TVA-BFN-TS-409

BROWNS FERRY NUCLEAR PLANT (BFN) - UNITS 1, 2, AND 3 - TECHNICAL SPECIFICATIONS (TS) CHANGE 409 - ADOPTION OF TS TASK FORCE (TSTF) TRAVELER - 287, REVISION 5 - CONTROL ROOM VENTILATION SYSTEM ENVELOPE - ALLOWED OUTAGE TIME

Technical Specifications (TS) Change 409 Adoption of TSTF-287, Revision 5 Control Room Ventilation System Envelope Allowed Outage Time

Proposed Technical Specifications Changes (mark-up)

CREV System
3.7.3

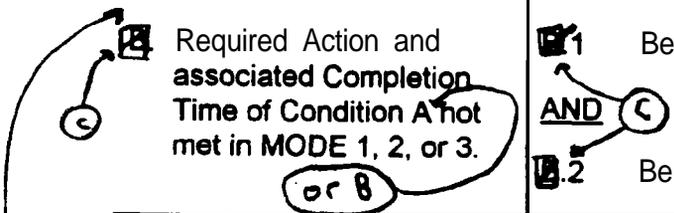
NOTE
 The main control room boundary may be opened intermittently **under administrative control.**

B. Two CREV subsystems inoperable due to inoperable control room boundary in modes 1, 2, and 3.	B.1 Restore control room boundary to OPERABLE status.	24 hours
---	---	----------

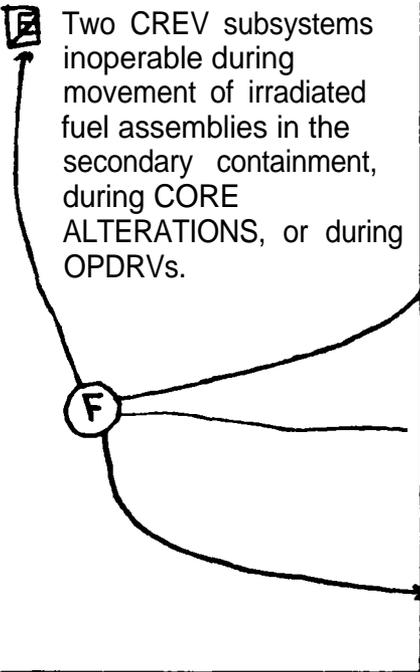
for reasons other than Condition B

BASES (continued)

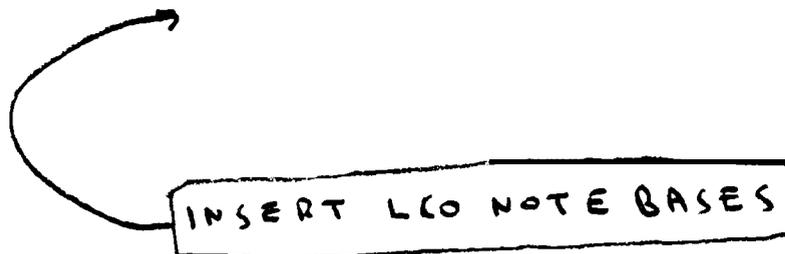
INSERT
LCO NOTE BASES (~~BWR-4 3.7.4, MREC System~~)

The LCO is modified by a Note allowing the main control room boundary to be opened intermittently under administrative controls. For entry and exit through doors **the** administrative control of the opening is performed by **the** person(s) entering or exiting the area For other openings, these controls consist of stationing a dedicated individual at **the** opening who is in continuous communication **with** the main control room. This individual will have a method to rapidly close the opening when a need for main control room isolation is indicated.
